Technical Service Bulletin

Subject: A/C BLOWS WARM AIR DUE TO REFRIGERANT LEAK FROM CONDENSER	Bulletin No.: 07-001/19
	Last Issued: 09/10/2019

APPLICABLE MODEL(S)/VINS

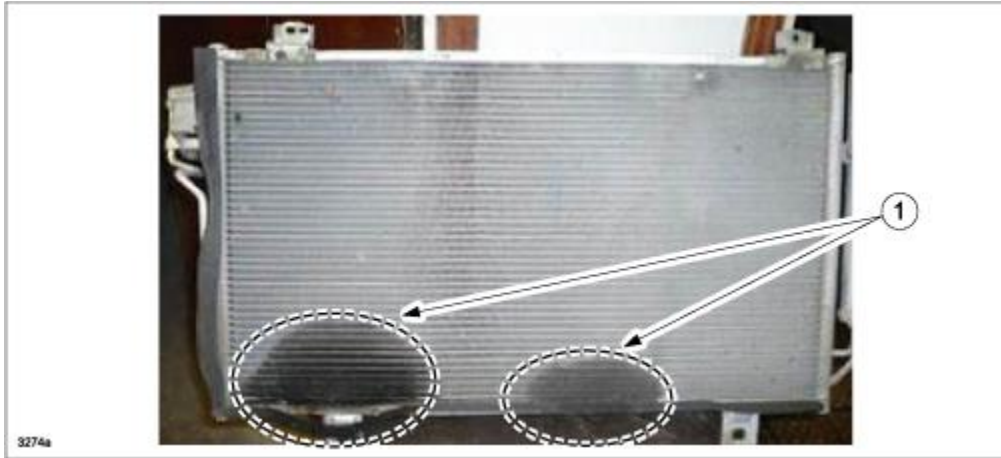
Some customers may complain about warm air from the climate control vents when the air conditioner is ON. This may be caused by condenser corrosion, causing a refrigerant leak.

The manufacturer of the condenser has been changed and the configuration of the condenser tube has been improved.

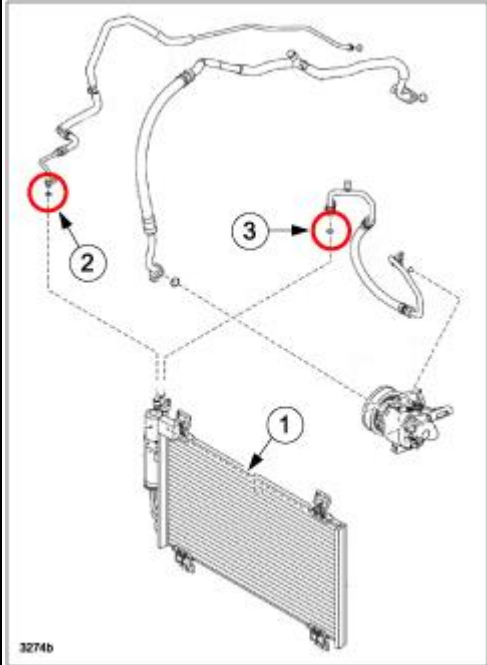
1. Verify the customer concern.
2. Visually inspect the condenser for A/C refrigerant leak.
 - Is there a visible trace of A/C refrigerant leaking at location (1)?

- Yes - Go to step 4.
 - No - Go to step 3.
3. Use a dealer supplied UV leak detection tool. Is there a trace of fluorescent liquid at location (1)?

- Yes - Go to step 4.
 - No - This Service Information is not applicable. Refer to MGSS online Workshop Manual (NO COOL AIR [FULL-AUTO AIR CONDITIONER]).
4. Replace the condenser according to the instructions on MGSS online (CONDENSER REMOVAL/INSTALLATION [SKYACTIV-G 2.0]).
 5. Verify the repair.
